From: Hannu Kemppinen [hkemppin@joyceengineering.com]
Sent: Tuesday, November 22, 2011 3:50 PM
To: Wilson, Donna
Cc: Nick Marotta (nmarotta@wcamerica.com); Dennis Gehle (dgehle@wcamerica.com); Evan Andrews
Subject: WCA Cell 1 of Phase 2A RTC 1
Attachments: Figure B Modified Facility Plan.pdf; RTC 1 Permit No 92-31 CQA Report.pdf; WCA Brownfield Rd Cell 1 of Phase 2A CQA Report.pdf; WCA Certification Letter.pdf; Cover 11-22-11.pdf; Figure A Facility Layout.pdf

CELL 1 of PHASE 2A CONSTRUCTION
BROWNFIELD ROAD C&D LANDFILL
NCDENR PERMIT # 92-31

On behalf of WCA of North Carolina, Joyce Engineering has prepared the below responses to your comments regarding the CQA report for Cell 1 of Phase 2A of the Brownfield Road Material Recovery C&D Landfill. Your comments are below as they appeared in your letter dated October 19, 2011. Our responses are in **bold font**.

FIGURE A - Facility Layout
(Waste Boundaries are Approximate)

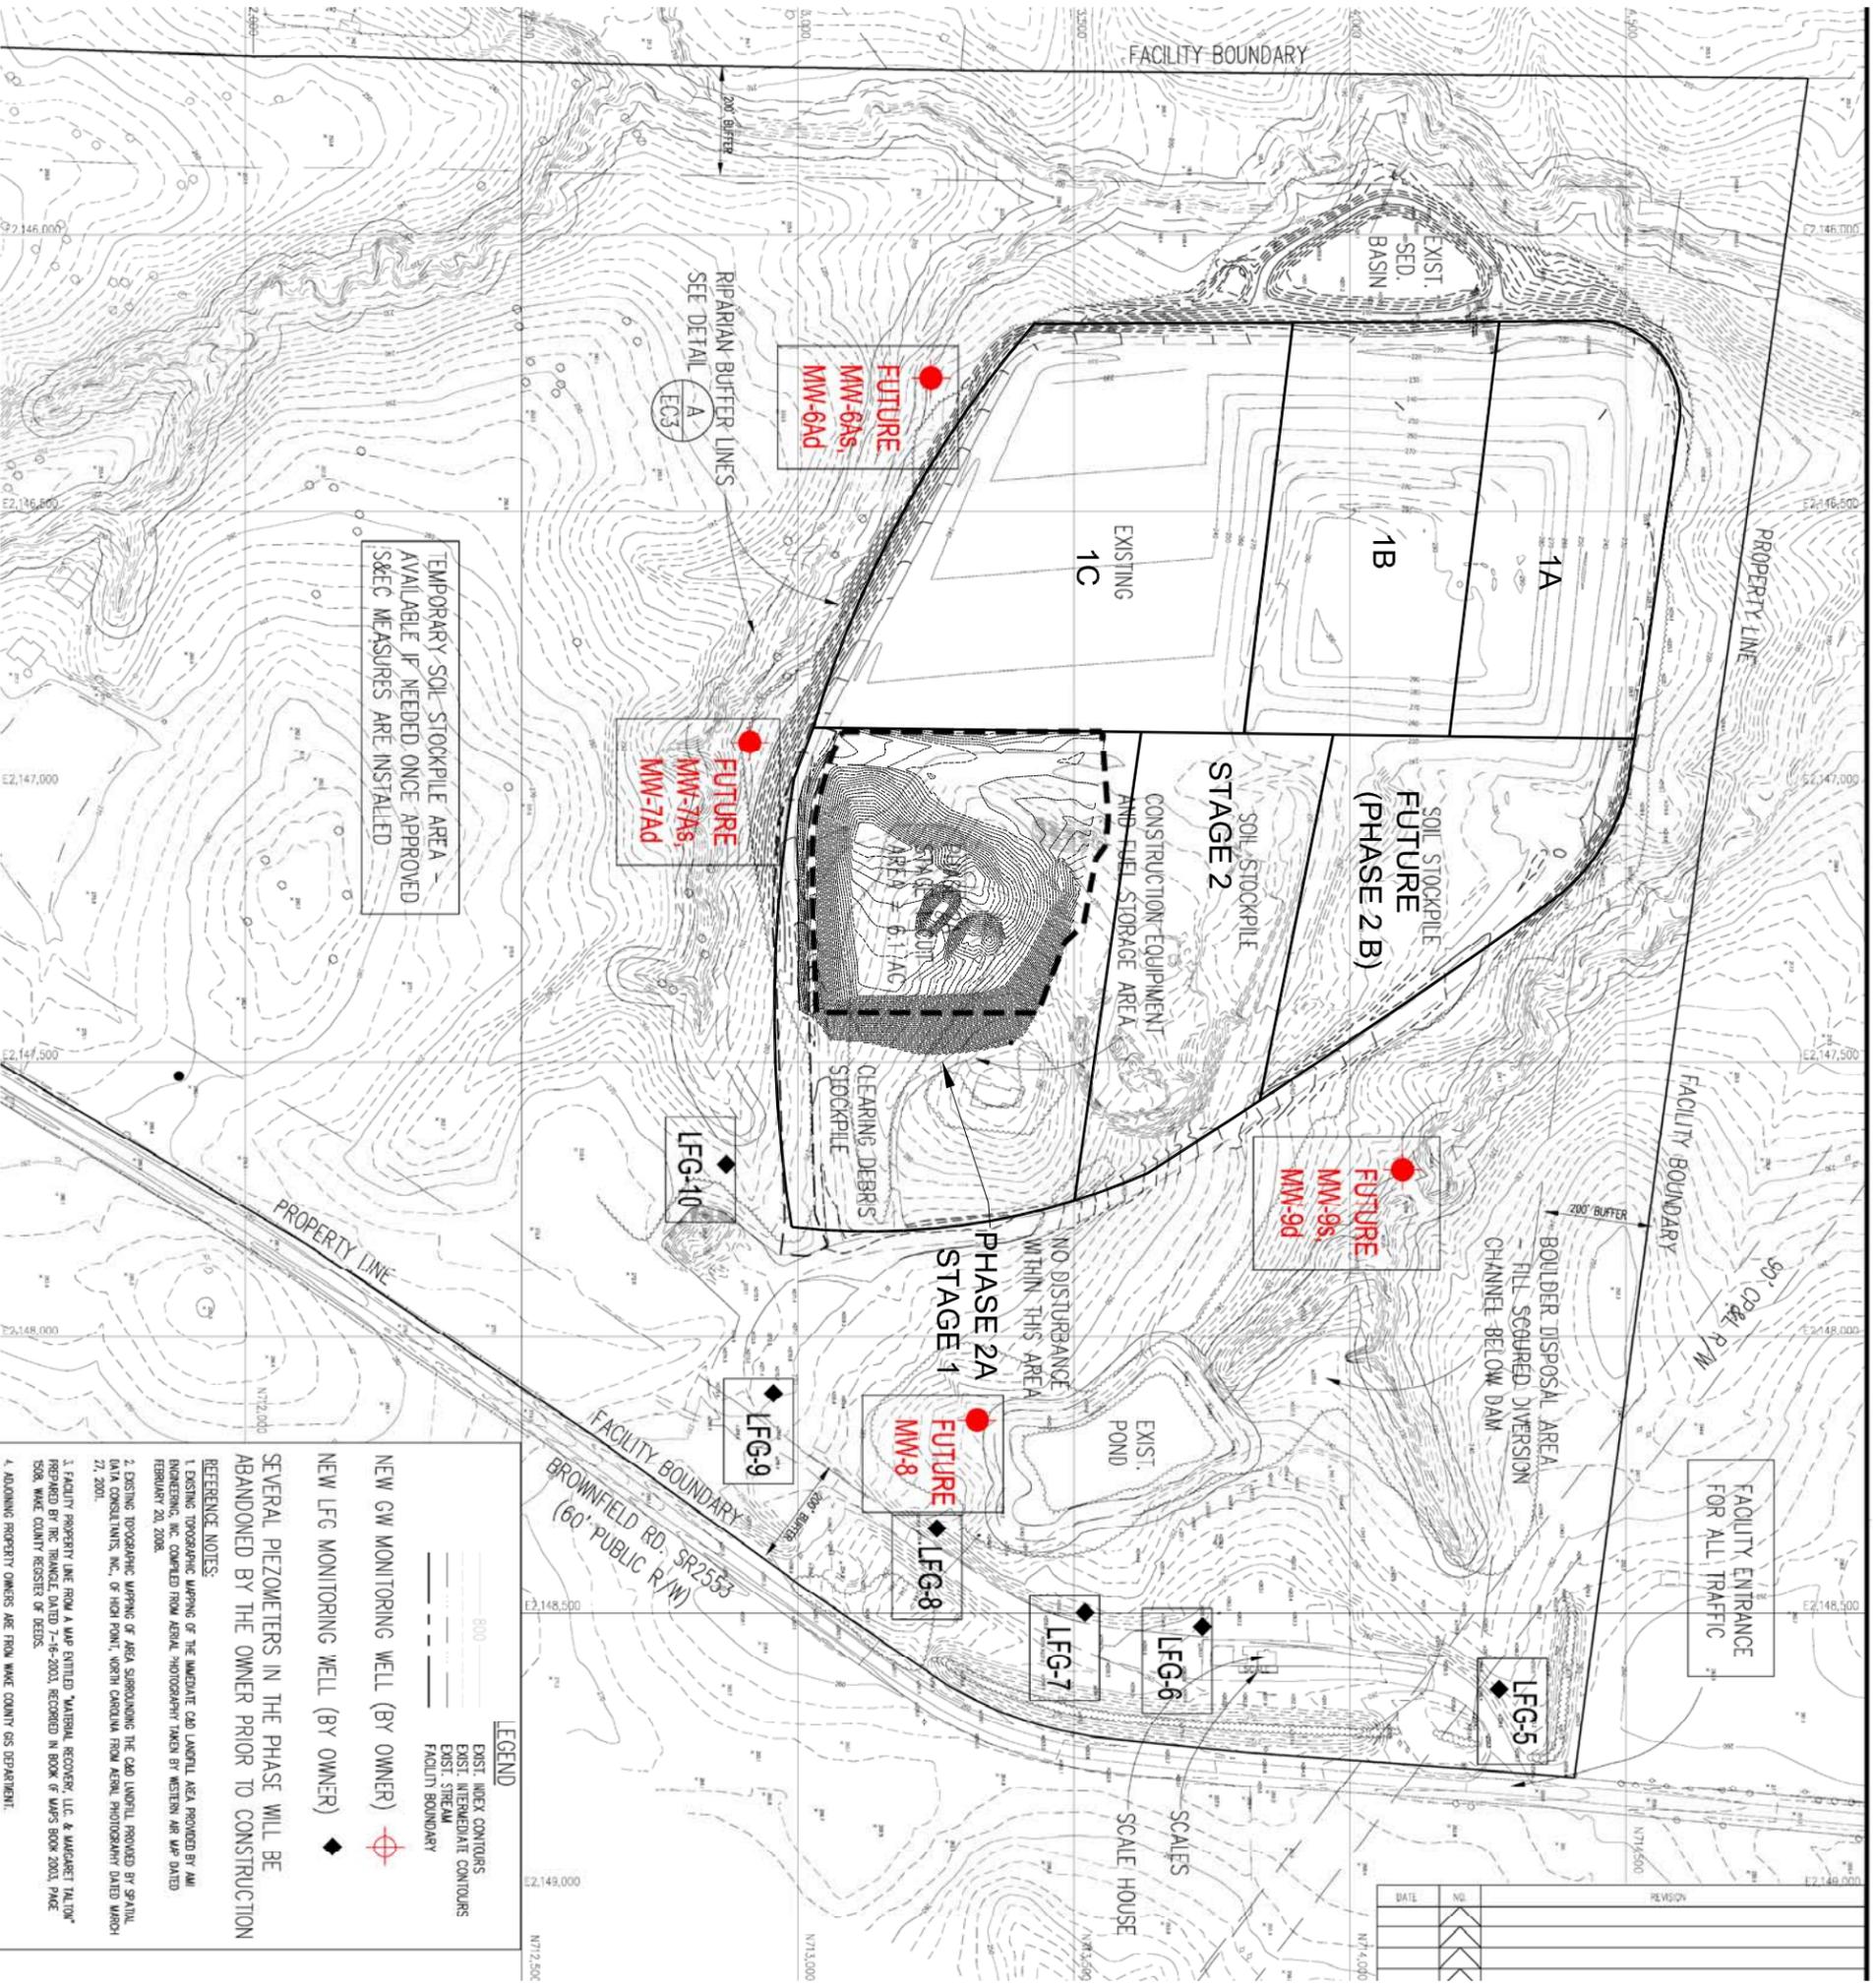
2. Since only a portion of Phase 2A was constructed, provide a drawing showing the boundaries of Cell 1 and the other planned cells in Phase 2A, making up the total boundary of Phase 2A. Also provide the acreage of the cells and the approximate volume of each cell.

Figure A- Facility Layout; from the permit application and Figure B - Modified Facility Plan for Cell 1 Phase 2A; are included to address requested information. Joyce Engineering does not have permit drawings in our possession, thus the Figures A and B are included to clarify the Phase 1 and 2 boundaries, and the constructed Cell 1 of Phase 2A.
